City of Portsmouth
Department of Public Works

Bid Proposal #30-06
Shoreline Repairs Prescott Park and Four Tree Island
Addendum #1
January 27, 2006

PRESCOTT PARK SECTIONS

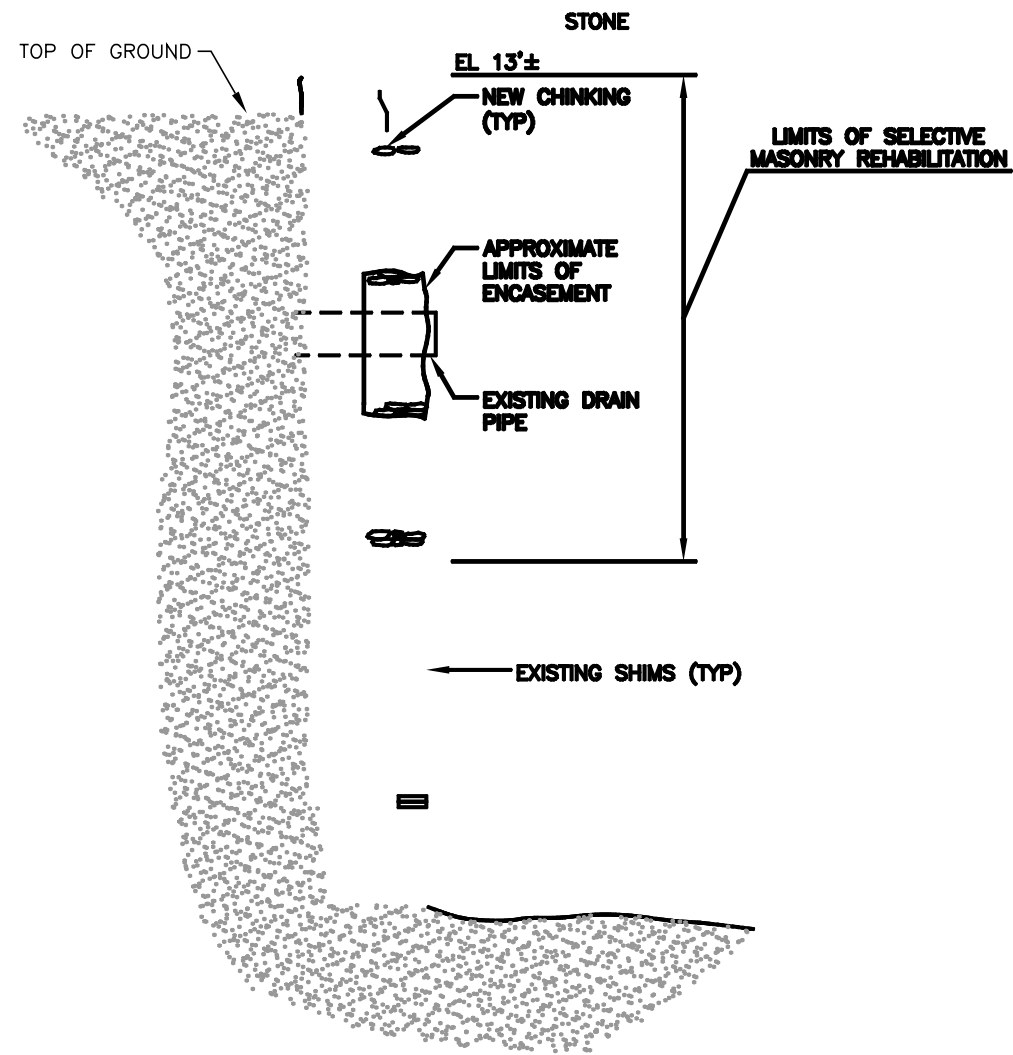
1. Excavate old 30" CI drain pipe from where it exits the ground at approximately mid-tide level to its termination near the end of the existing pier. (Approximately 100 LF)
2. This new termination shall be slip-lined with a 27" PVC pipe and mortared in place for a minimum length of 10'. Contractor to confirm the pipe size.
3. Rip Rap Class A shall be placed around the new out-fall to stabilize the structure in accordance with the Standard Details Sheet 2 of 3 entitled Prescott Park Sections.
